FOR THE MEETING OF: July 23, 2019
CASE NO.: DR-SPR-ADJ19-05
AGENDA ITEM: 5.3

APPLICATION: Consolidated Class 3 Design Review, Class 3 Site Plan Review, and Class 2 Adjustment

CASE NO.: DR-SPR-ADJ19-05

LOCATION: 451 - 465 Division Street NE (Marion County Assessor Map and Tax Lot Number: 073W22DA09800) (Attachment A)

SHEET **A3.1**

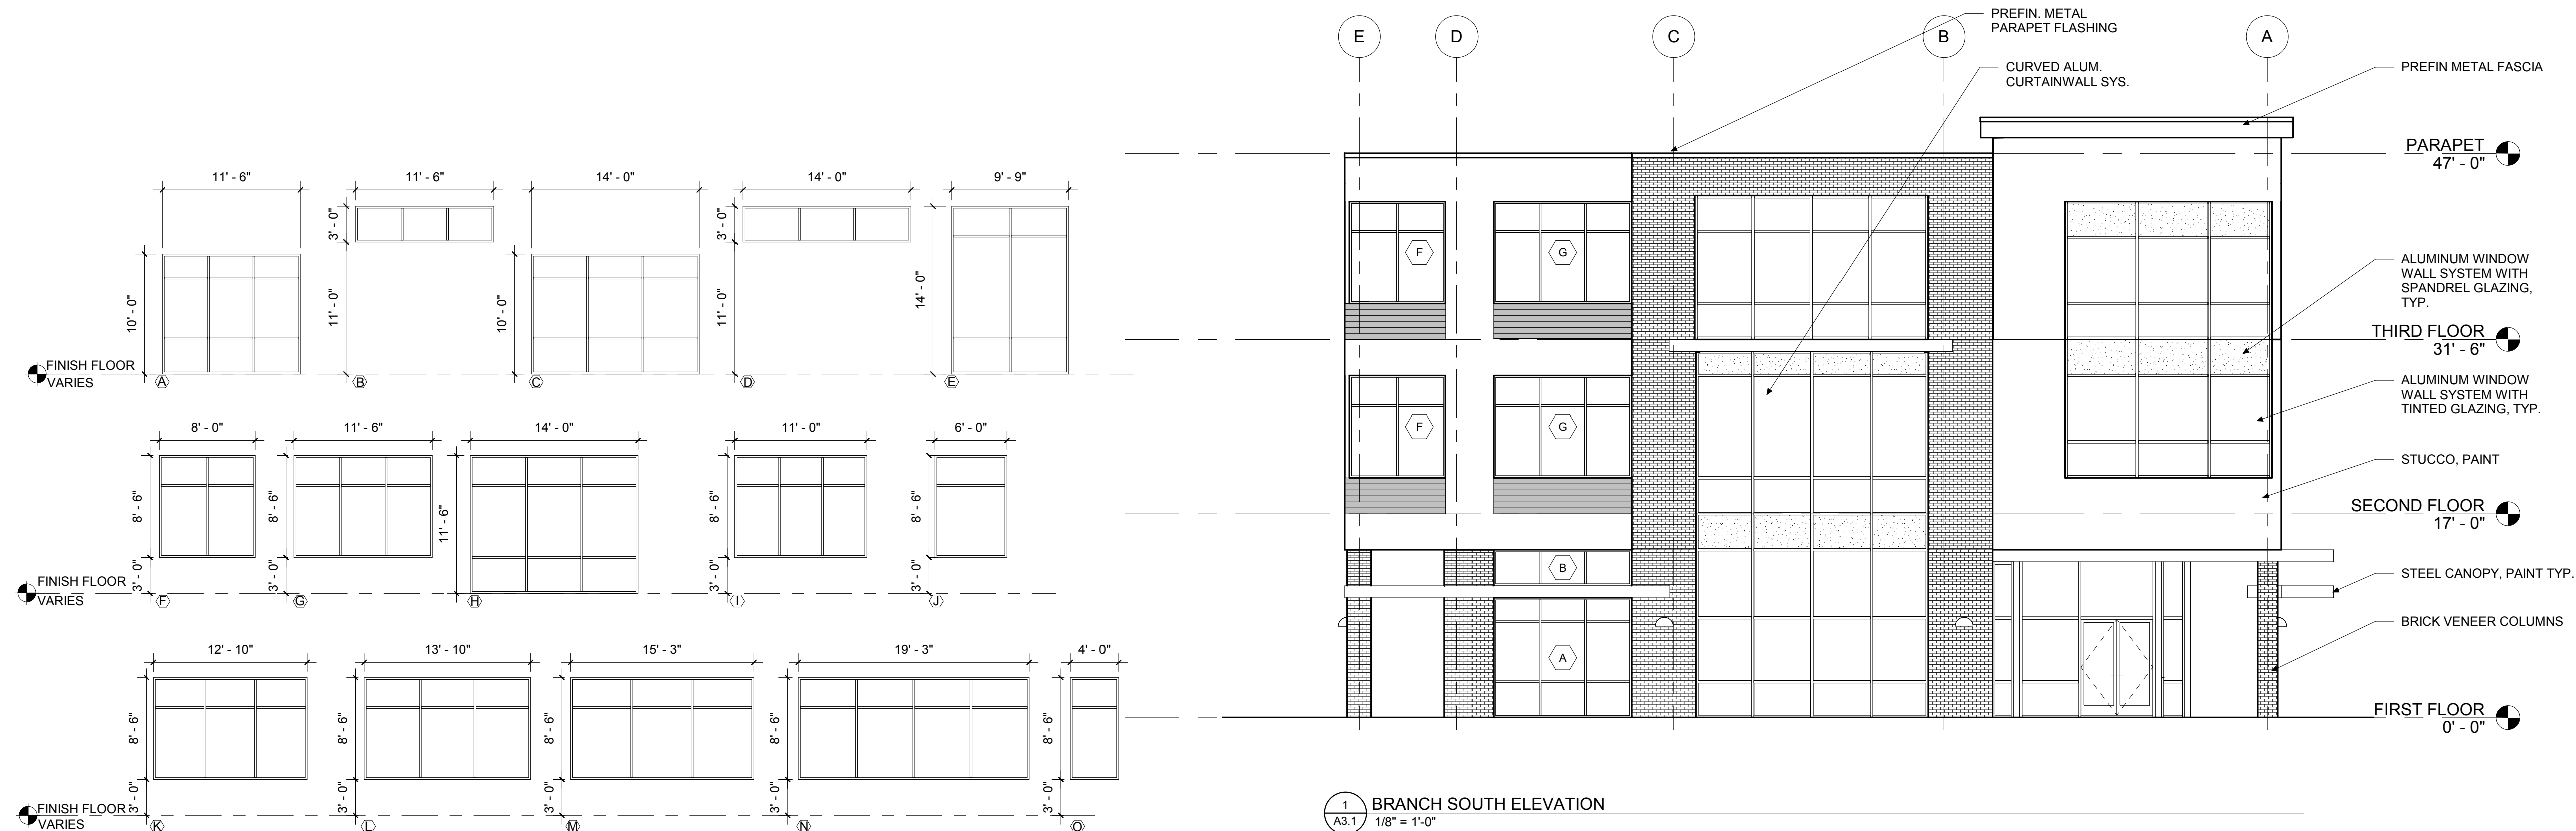
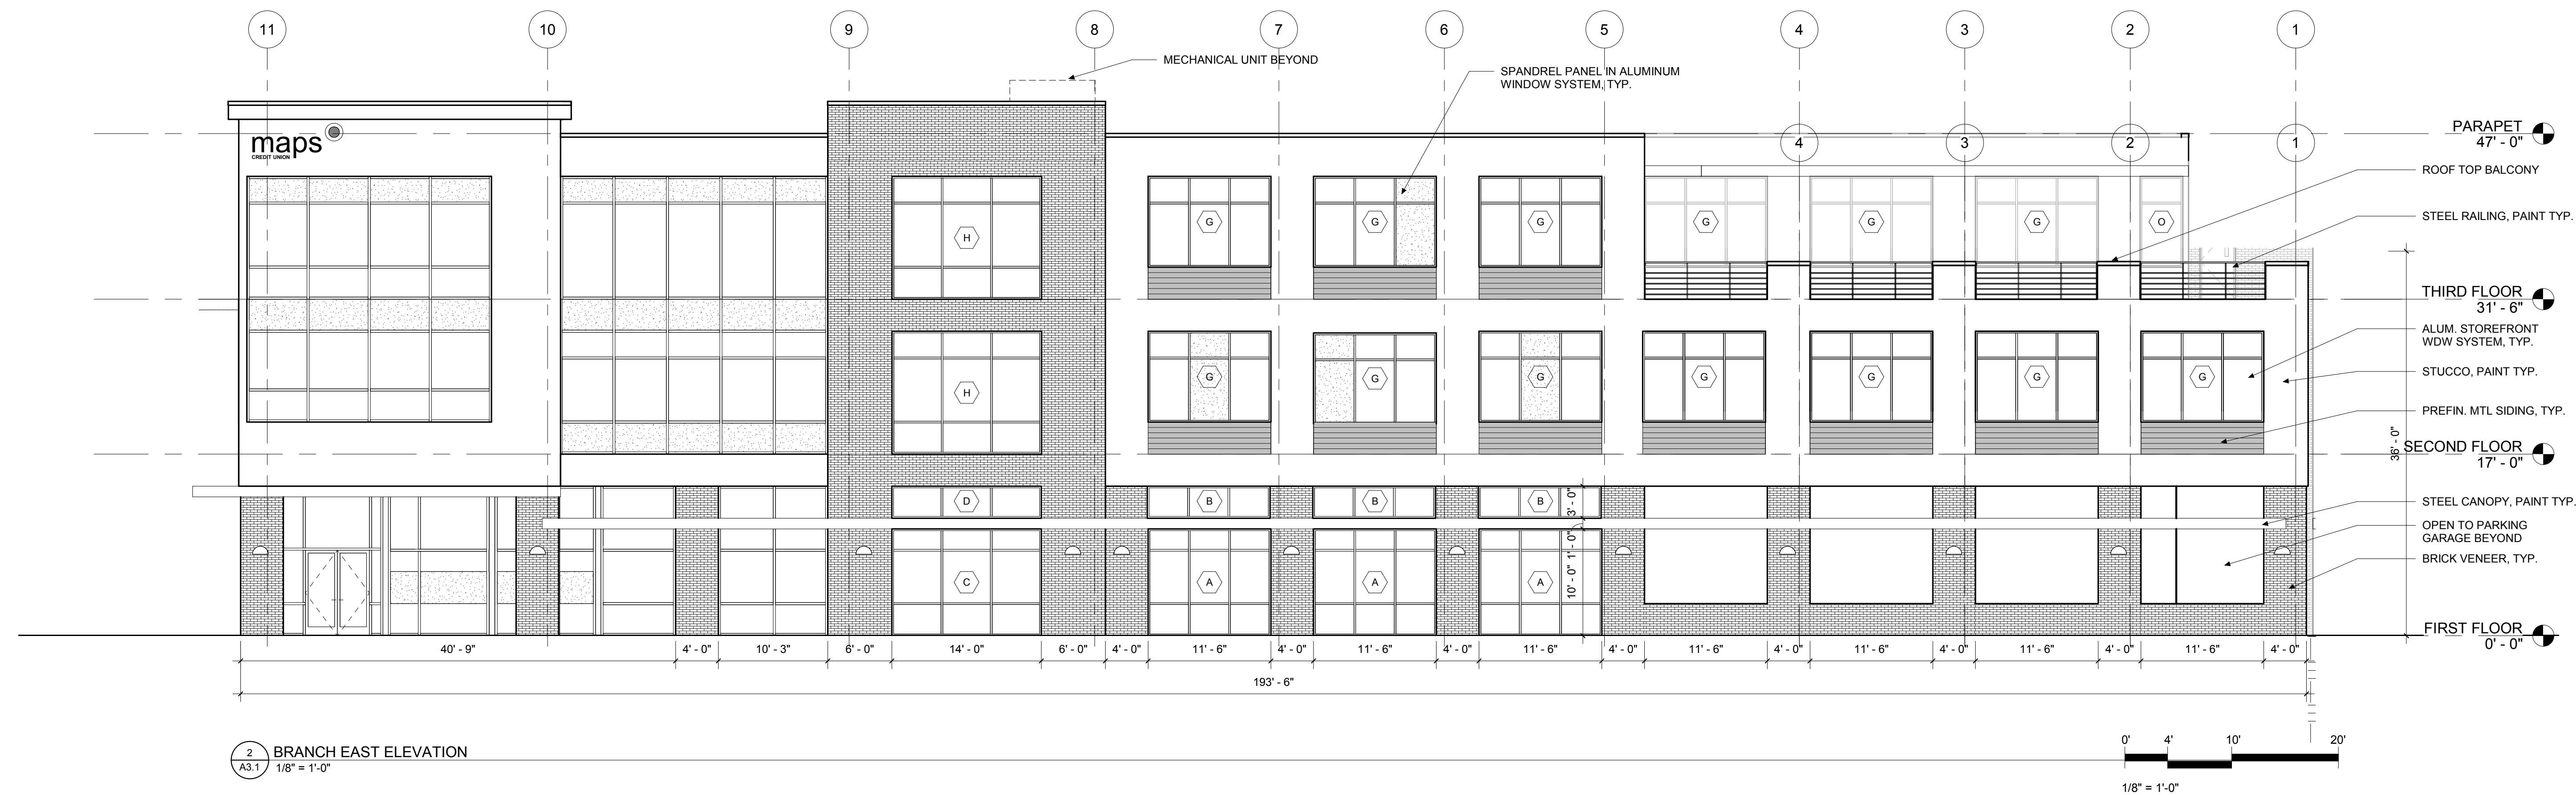
(ii) Ground floor building facades facing Broadway/High Street shall include transparent windows to ensure that the ground floor promotes a sense of interaction between activities in the building and activities in the public realm.

The proposal includes 146 linear feet of glazing over 6 feet tall along 193.5 feet of building length along High Street, or 75 percent, meeting the standard. The proposed facility conforms to this design guideline.

Finding: The written statement provided by the applicant (**Attachment D**) indicates that the proposal meets the guideline by complying with the corresponding design review standard: Building offsets and articulation shall be provided for building frontages greater than 100 feet of length in order to create pedestrian scale.

The proposal includes four offsets along the façade facing High Street. Offsets are provided at ground level and on upper level floors, meeting the standard. The proposed facility conforms to this design guideline.

(iv) *Weather protection, in the form of awnings or canopies appropriate to the design of the building, shall be provided along ground floor building facades adjacent to a street in order to create a comfortable and inviting pedestrian environment.*

The ground floor on Division Street has awnings over approximately 66 percent of its length, and the ground floor on High Street has awnings over approximately 99 percent of its length, meeting the standard. The proposed facility conforms to this design guideline.
